**RANGELINE CROSSING SUBDIVISION,**  
**RESUBDIVISION OF LOT A OF THE RESUBDIVISION**  
**OF LOT 2**

APPLICATION NUMBER 7 DATE January 5, 2017  
 APPLICANT Rangeline Crossing Subdivision, Resubdivision of Lot A of the Resubdivision of Lot 2  
 REQUEST Subdivision

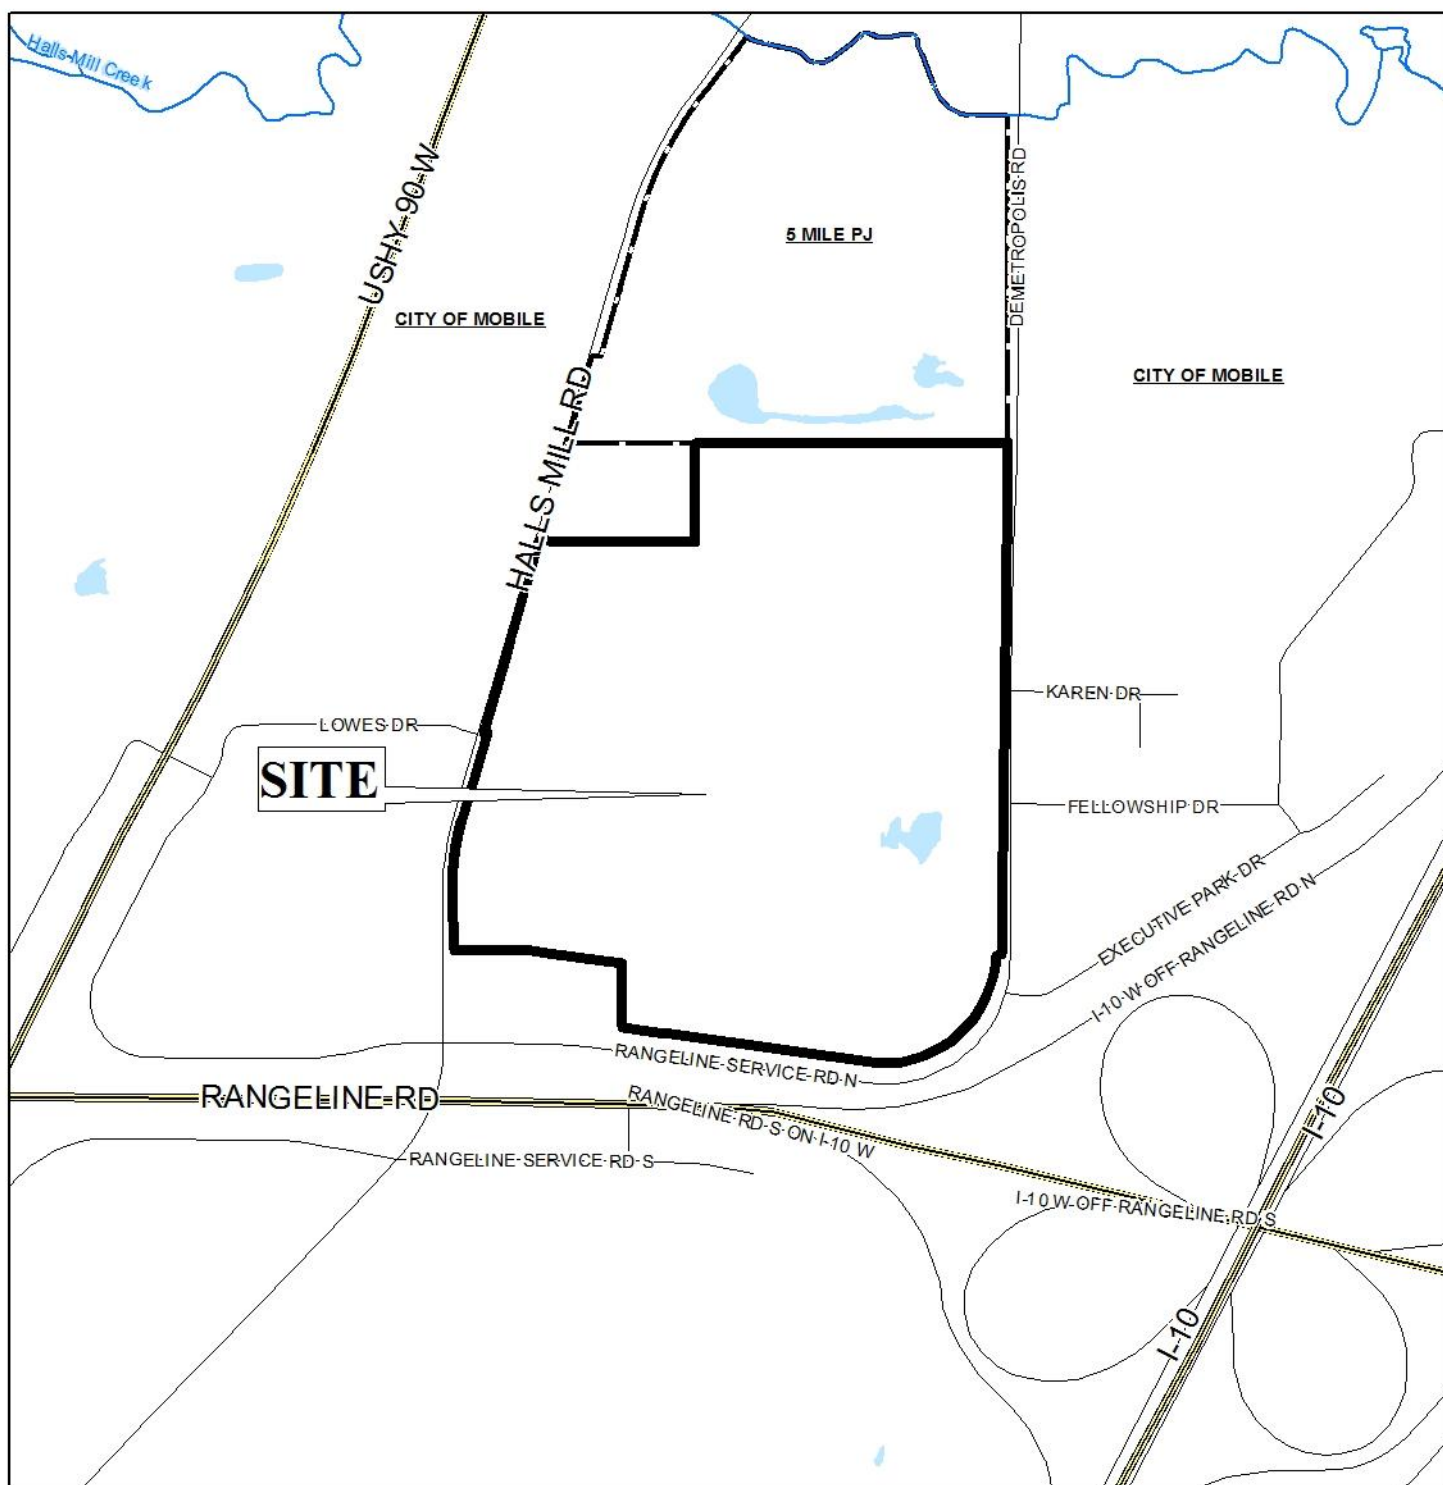
The site has frontage onto three streets: Demetropolis Road on the East, Rangeline Road service road on the South, and Halls Mill Road to the West. Previous subdivisions have addressed any right-of-way width issues, thus dedication will not be required.

Access management is a concern due to the site's location between three streets, one of which is a major street, and the proximity to an interchange for Interstate 10. Each proposed lot should be limited to a maximum of two curb-cuts to each abutting street frontage, with the size, design and location of all curb-cuts to be approved by Traffic Engineering, and ALDOT where appropriate, and conform with AASHTO standards.

The minimum building setback line, required in Section V.D.9., is shown for the subdivision. In several instances, there are drainage or utility easements with supersede the standard 25 foot minimum setback requirement, and this is depicted on the preliminary plat.

Numerous drainage, utility and access easements are depicted on the preliminary plat. These easements should be retained on the final plat. A note should also be placed on the final plat stating that no structures that are not associated with the underlying easement may be placed in the easement.

- 1) Provision of seven (7) copies of the recorded plat for Rangeline Crossing, Resubdivision of Lot 2, prior to the signing of the plat for this request;
- 2) Placement of a note on the final plat stating that development of all lots is limited to an approved Planned Unit Development;
- 3) Placement of a note on the final plat stating that each lot is limited to a total of two (2) curb-cuts per street frontage, with the size, design and location of all curb-cuts to be

- approved by Traffic Engineering, and ALDOT where appropriate, and conform to AASHTO standards;
- 4) Retention and labeling of at least a 25-foot minimum building setback line from all street frontages, as required by Section V.D.9. of the Subdivision Regulations;

- 5) Retention of the lot size in square feet and acres;
  - 6) Retention and labeling of all easements on the final plat, and placement of a note on the final plat stating that no structures that are not associated with the underlying easement may be placed in the easement;

# DETAIL SITE PLAN

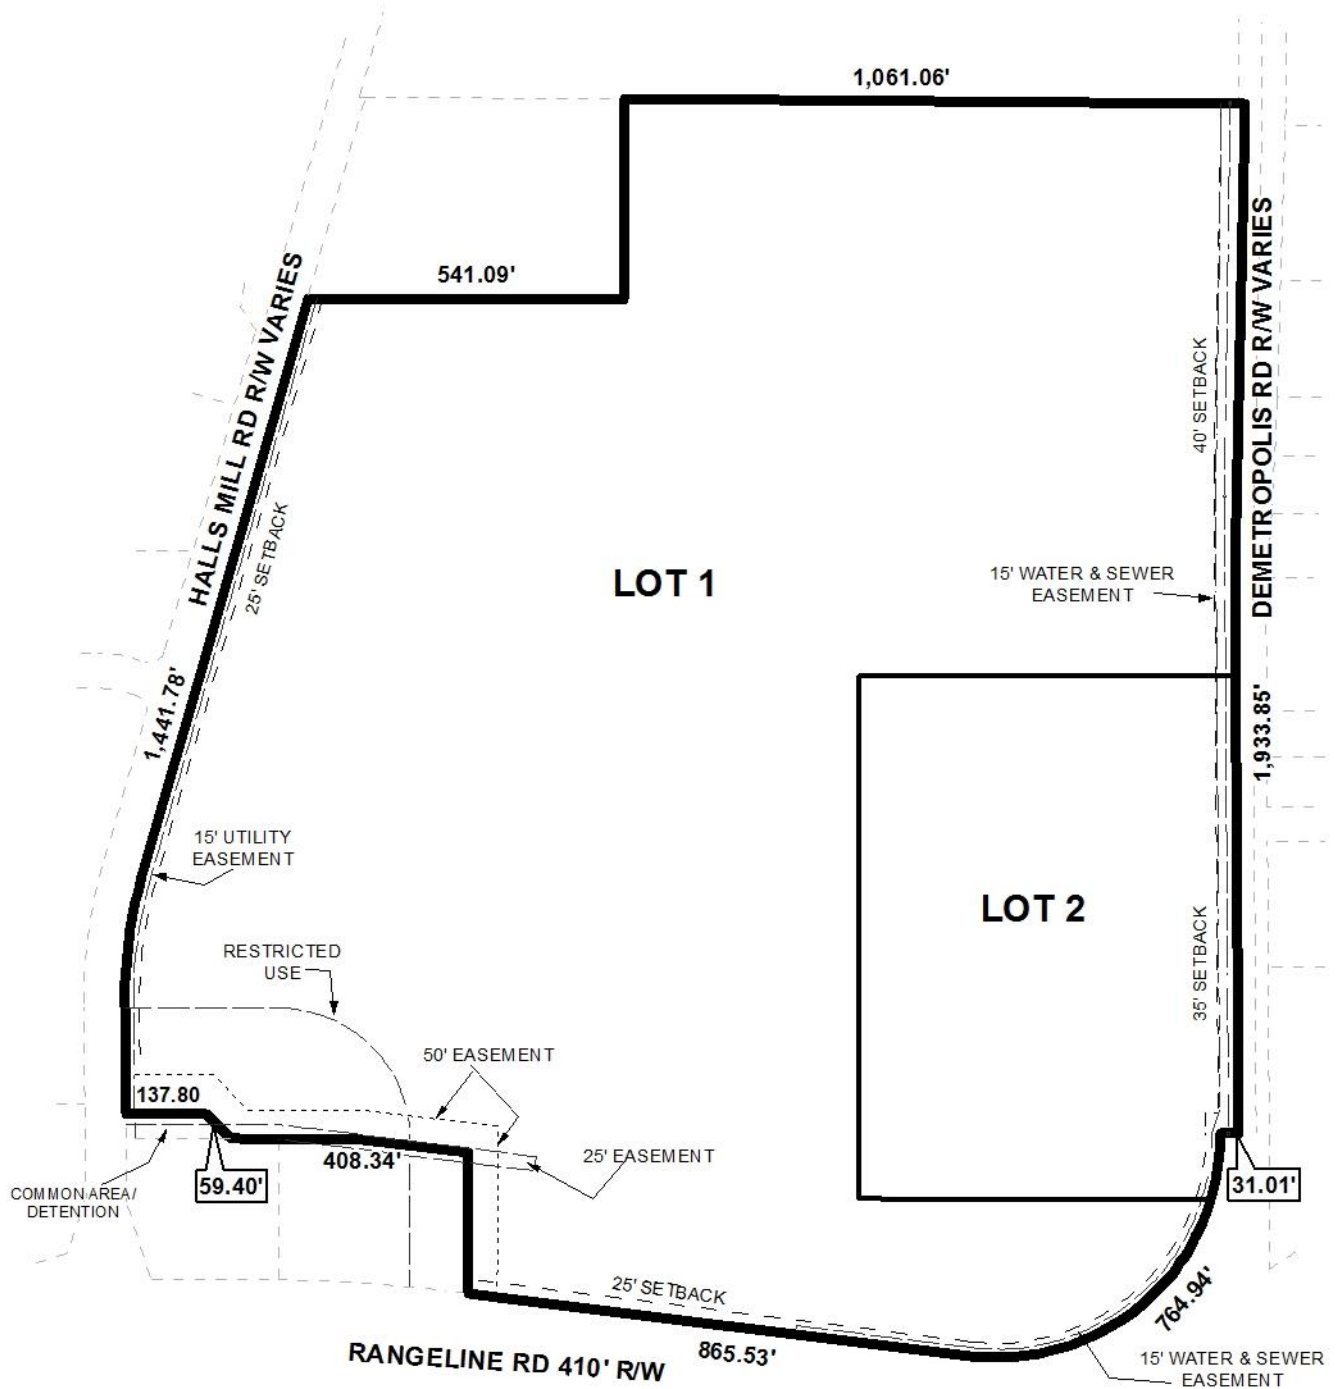
- A. Provide all of the required information on the SUBDIVISION PLAT (i.e. signature blocks, signatures, certification statements, written legal description, required notes, legend, scale, bearings and distances) that is required by the current Alabama State Board of Licensure for Professional Engineers and Land Surveyors.

- B. Review and revise the written legal description to match the drawing.
- C. Show and label the existing LOT A.
- D. Add a signature block for the Owner, Notary Public, Planning Commission, Traffic Engineer, and City Engineer.

- E. Provide the Surveyor's, Owner's (notarized), Planning Commission, and Traffic Engineering signatures.
- F. Add a note to the Plat stating that the approval of all applicable federal, state, and local agencies (including all storm water runoff, wetland and floodplain requirements) will be required prior to the issuance of a Land Disturbance permit.
